DEPARTMENT OF THE AIR FORCE
HEADQUARTERS UNITED STATES AIR FORCE
BOLLING AFB DC 20332

SUBJECT Notification of Change (USNRC License STB-1407)

1 Atch
Sketch of Location Change
in Building 3001

GEARBOX SHOPS J.79

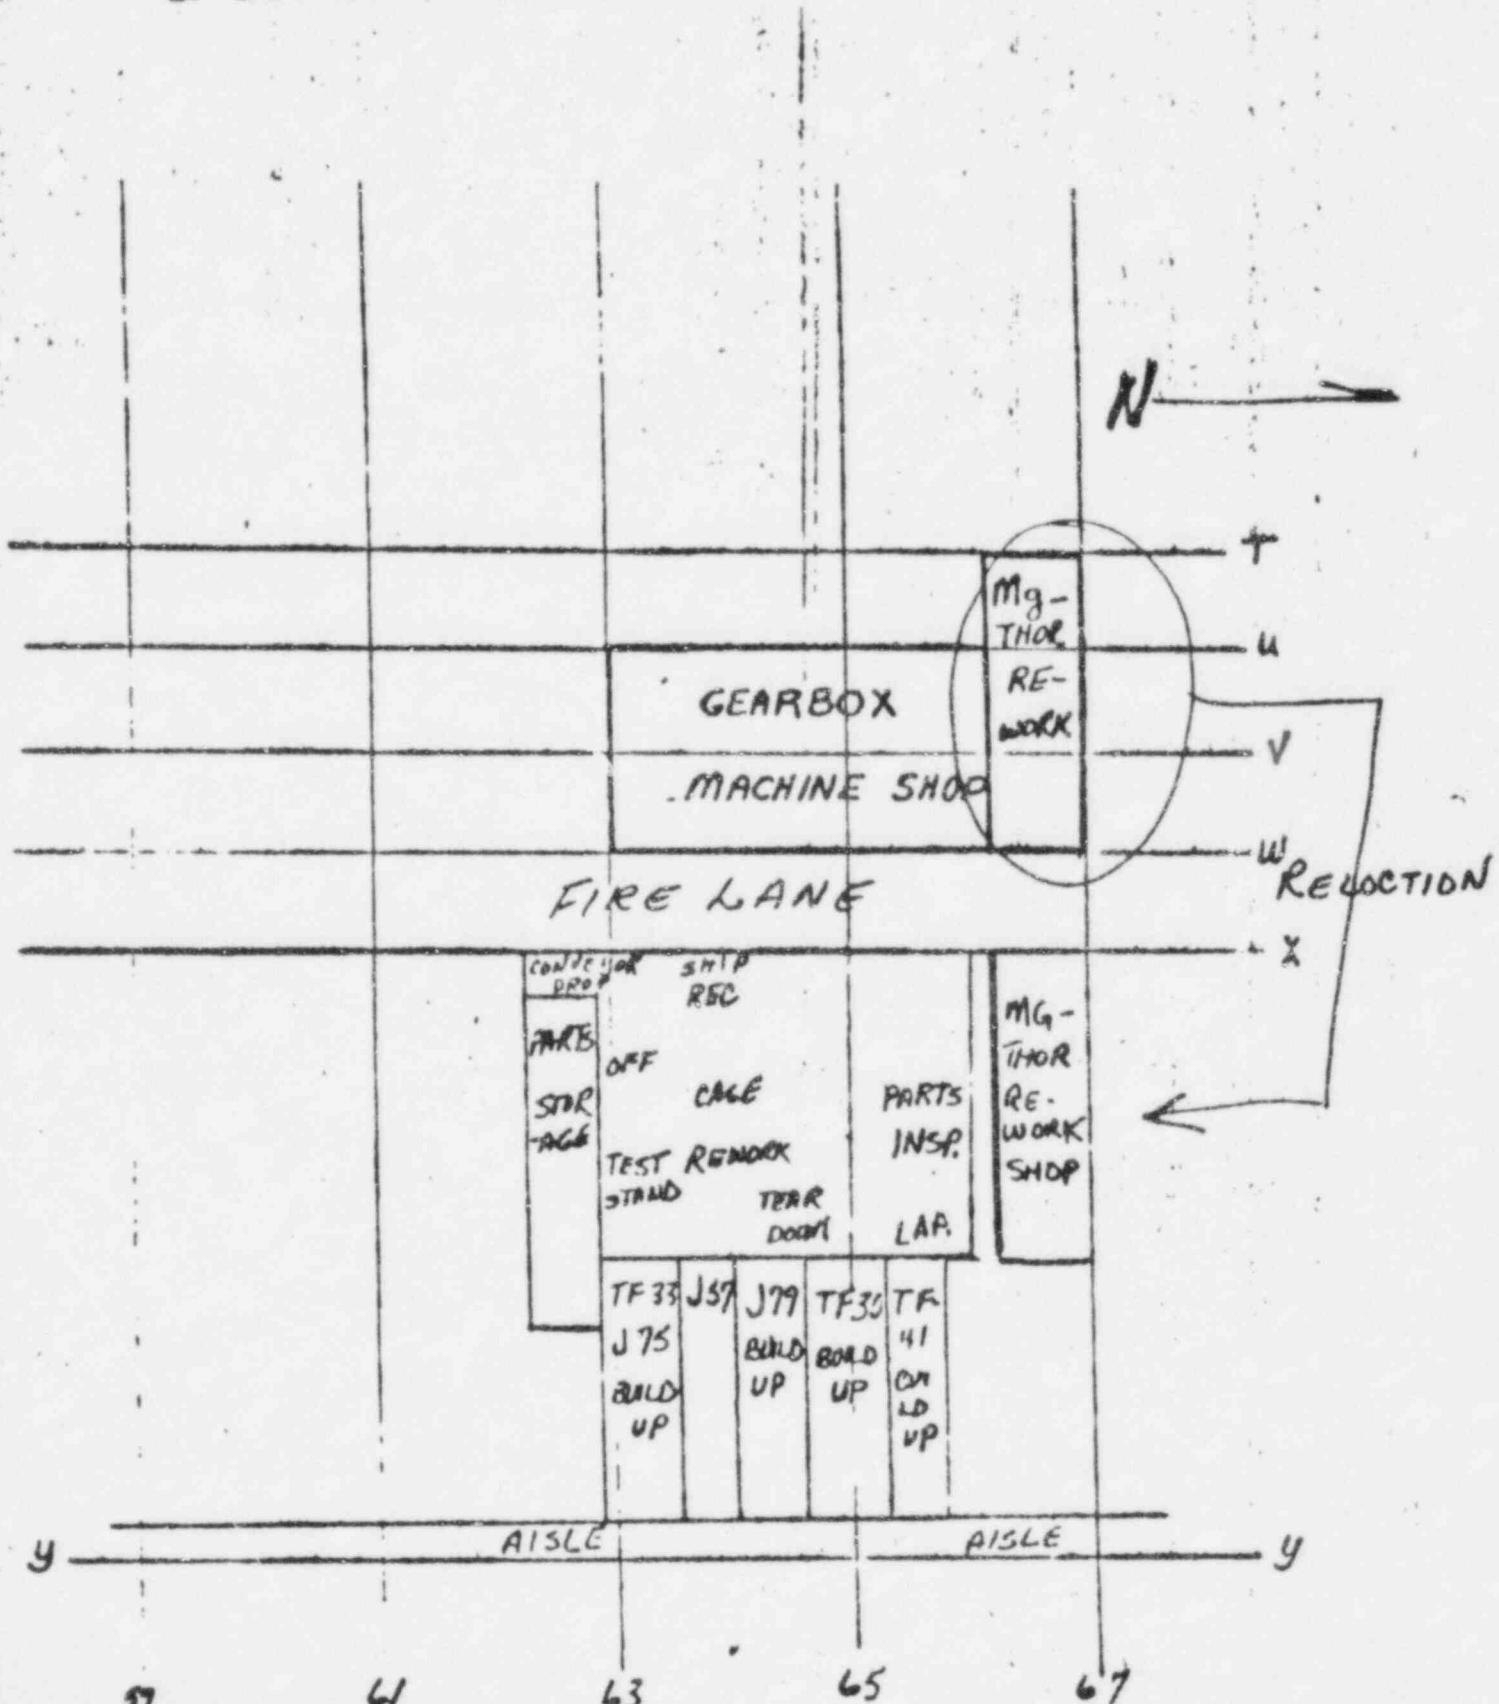
1. This is to advise you of a change in the planned location for repair/rework of magnesium-thorium components authorized by license number STB-1407 issued February 22, 1982 to the Directorate of Maintenance, Tinker Air Force Base, Oklahoma.
2. The gear box repair/rework was to have originally been conducted within an enclosure constructed in area T-67-W-67 of building 3001. Subsequent plant layout modifications now require this enclosure to be located in area X-67-Y-67 within the same building. This relocation is illustrated on the attached diagram. Since no work has yet been started, this simple relocation does not change any radiological health considerations of this license, nor any other representations made in the original application dated October 13, 1981.
3. Please refer any subsequent correspondence on this subject to this office.
